Replacement Cross Reference

FW Murphy P.O. Box 470248 Tulsa, Oklahoma 74147 USA (918) 317-4100 fax (918) 317-4266 e-mail sales@fwmurphy.com MS21-01094A Sect. 25; Effective 09-01 (00-02-0488)

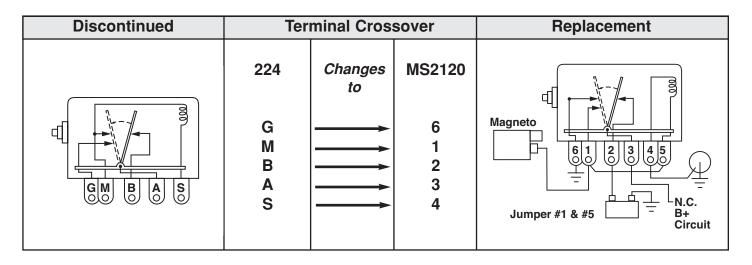
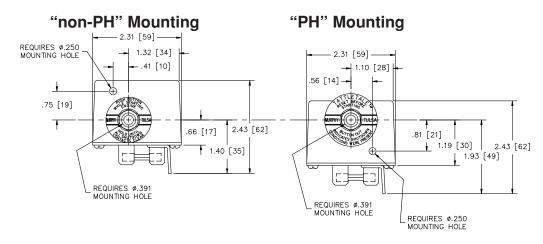
This magnetic switch replaces the models shown in the left hand column. Non "PH" models (e.g. 307, 307CD, 274, etc.) are discontinued and are replaced by the new models shown in this Cross Reference. Note the mounting differences between old "PH" and old "non-PH" models. All new models have the same mounting as the old "PH" models. A mounting template is includ-

ed in the unit carton for the new model. Otherwise, operation is the same for old and new models. Terminal crossover letters/numbers are shown for each model. Note in some cases terminal(s) are not used with the new model. Also note that a jumper (provided in the hardware package) may also be required.
